Docket Number:	00-AFC-01C
Project Title:	Contra Costa Power Plant Project Compliance
TN #:	204675
Document Title:	Petition for Insignificant Project Change to Plant Facility
Description:	Additional Decking on the East Side of the Steam Turbine Deck
Filer:	Patty Paul
Organization:	Pacific Gas & Electric Company
Submitter Role:	Applicant Representative
Submission Date:	5/21/2015 8:36:39 AM
Docketed Date:	5/21/2015

Subject: PETITION FOR INSIGNIFICANT PROJECT CHANGE TO PLANT FACILITY
(Additional Decking on the East Side of the Steam Turbine Deck)

**PETITION FOR INSIGNIFICANT PROJECT CHANGE
AT
GATEWAY GENERATING STATION (GGS)**

1. Installation of Additional Decking on East Side of Steam Turbine Deck:

ELEVATION 2
SCALE: NTS

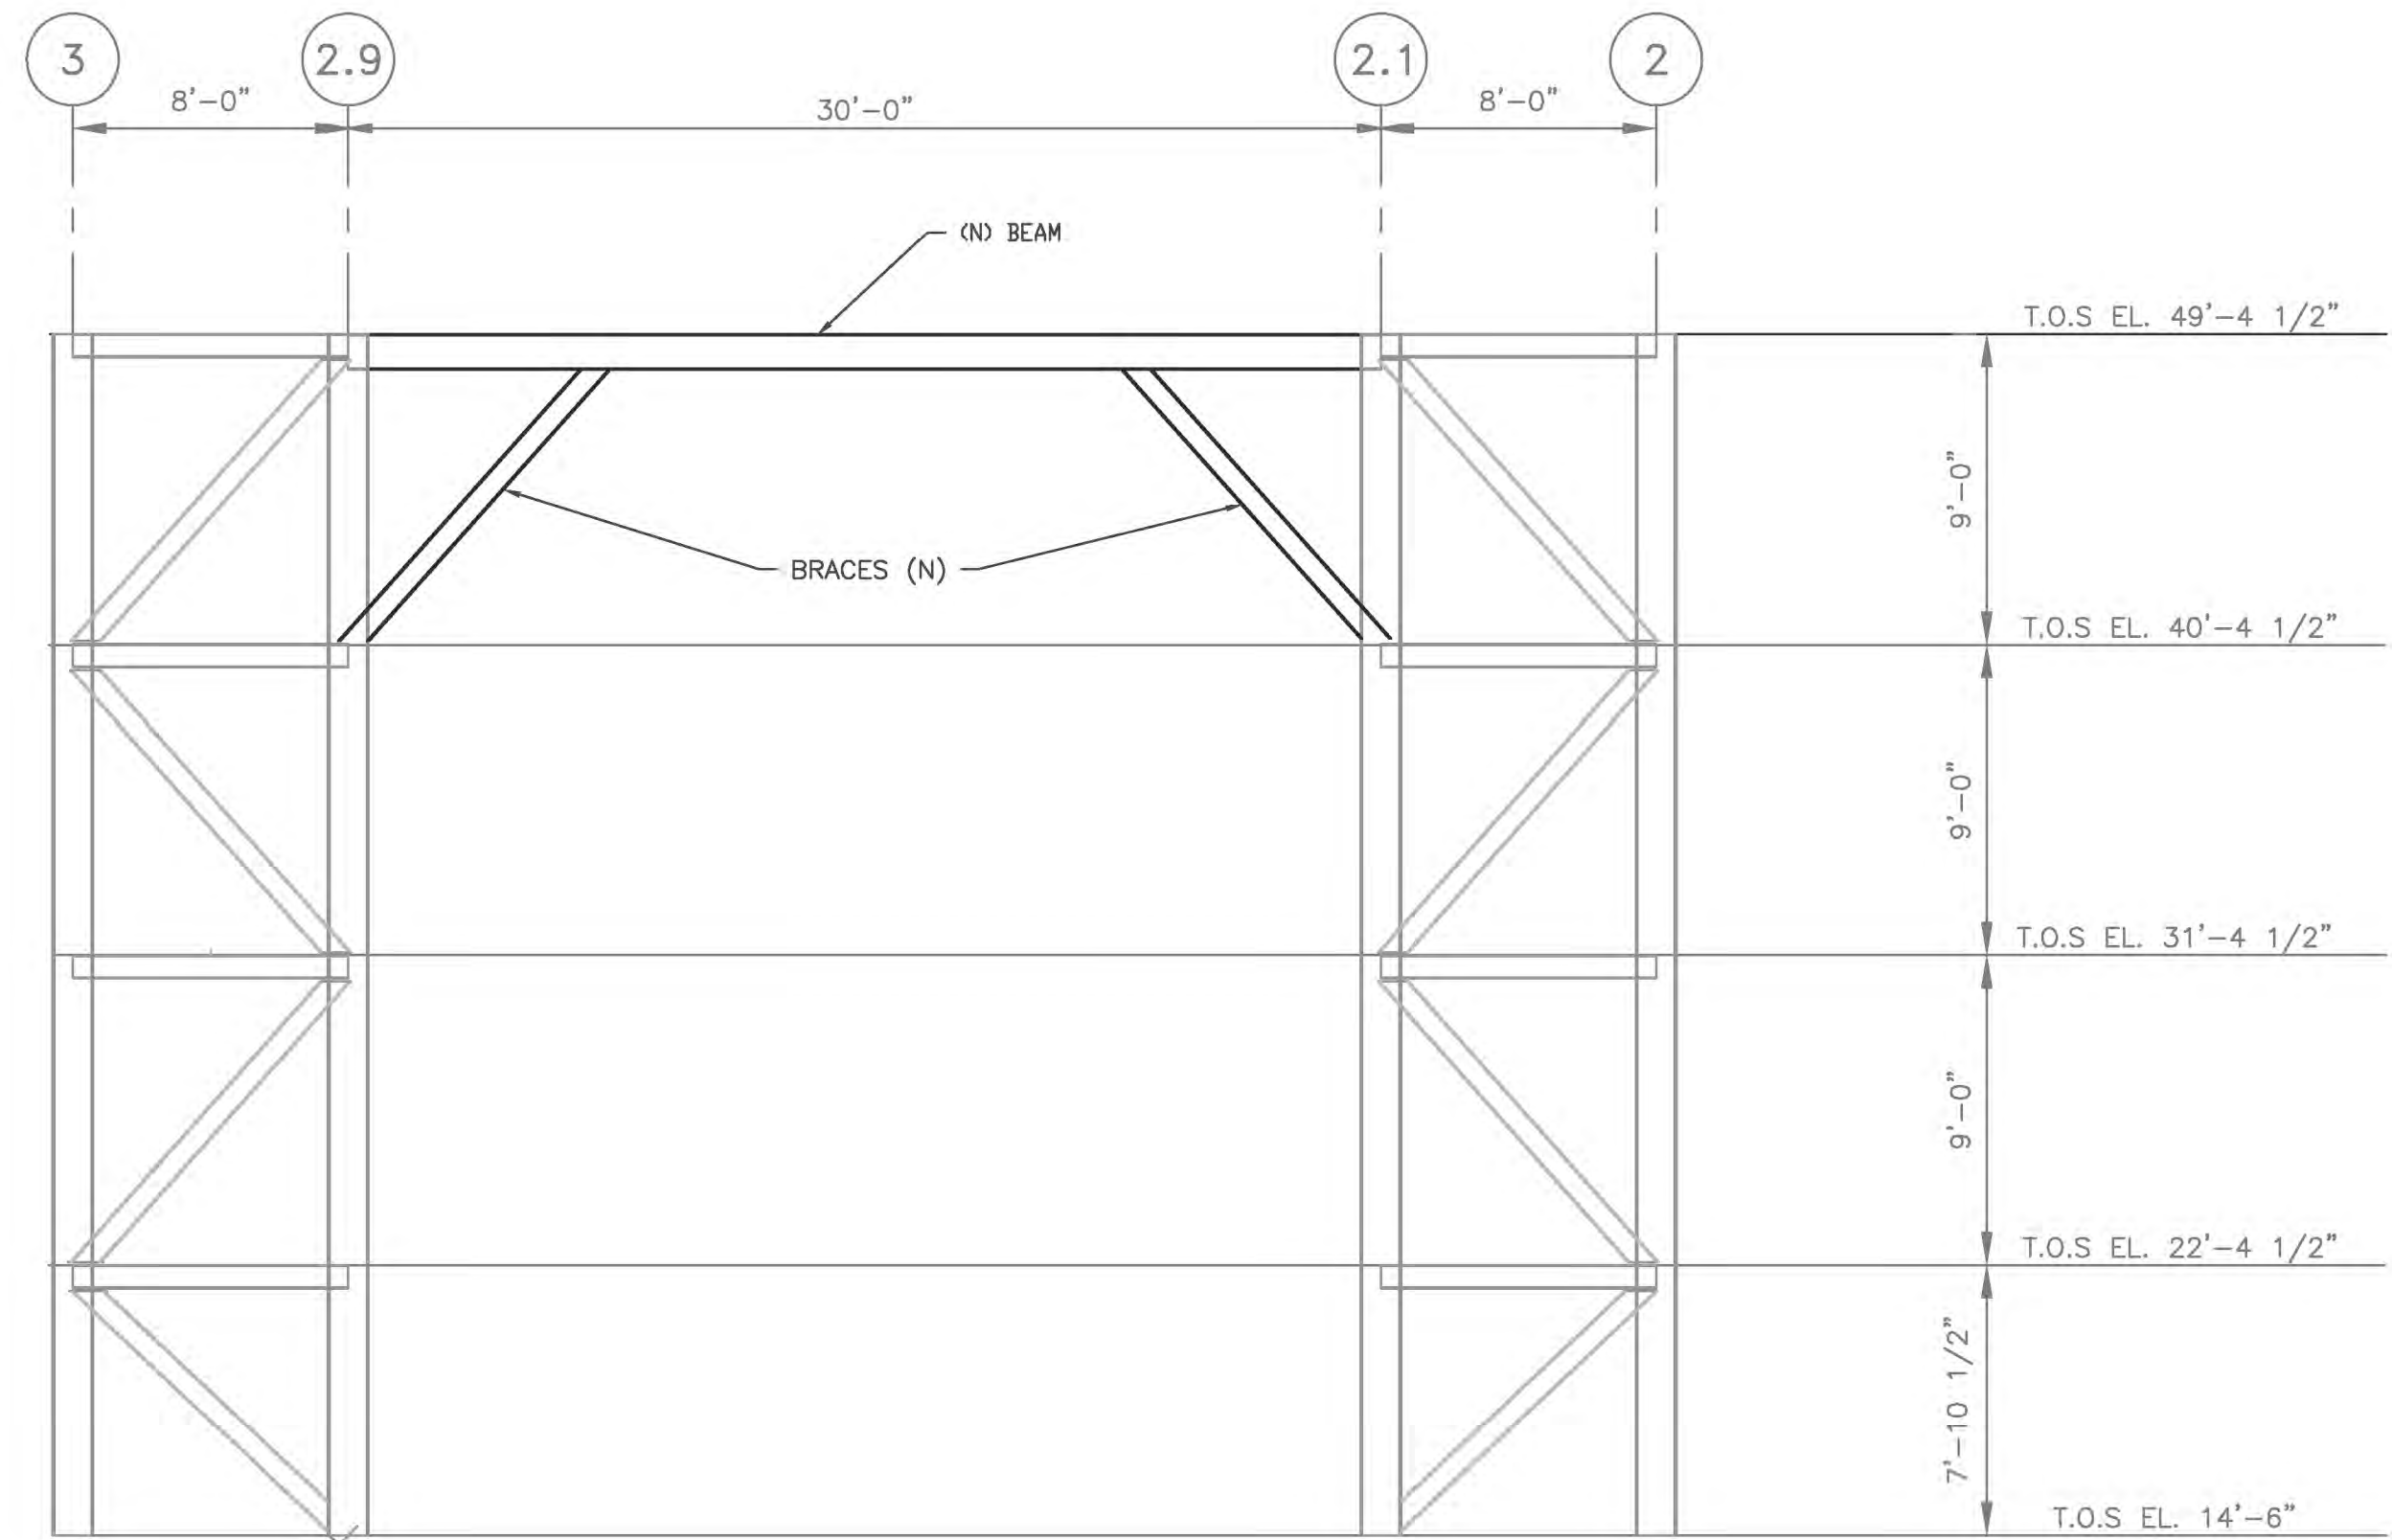
The current Gateway Generating Station (GGS) steam turbine deck configuration has one open area on its east side which was not originally fitted with grating-type decking during plant construction -- see proposed grating addition area outlined in red in left side lower half of Figure 1 (see attached drawing).

- a. Description of Modification: PG&E proposes to: (See the “Conceptual Demo Plan” portion of the left side upper half of Figure 1 for reference for Items 1 through 3): (1.) Remove the lighting and associated electrical power supply conduit runs currently installed along the west perimeter of the subject open Steam Turbine (ST) Deck area; (2) Remove the guard rails installed along the north, west and south perimeters of the subject open ST Deck area; (3) Perform the X-brace and east side structural beam modifications shown in the left side upper half of Figure 1; (4) Install additional structural brace beams – see the “Elevation 1” section of Figure 1 (south side of subject section of ST Deck looking north) and in the “Elevation 2” section of Figure 1 (east side of subject section of ST Deck looking west) – attached to the structural column beams and underlying horizontal decking support beams as shown in Elevations 1 and 2 of Figure 1, to provide support under the area to which grating-type decking is being added; (5) Install grating-type decking in the area outlined in red as depicted in the “Conceptual Const. Plan” portion of the left side lower half of Figure 1; (6) Re-install the lighting, associated electrical power supply conduit runs, and guard rail along the east perimeter of the subject open area. This proposed project will not require excavation or any ground disturbing activity. The relocation of lighting and electrical power supply conduit runs will be done above ground at the elevation of the existing turbine deck. This project is planned to be started in July 2015.
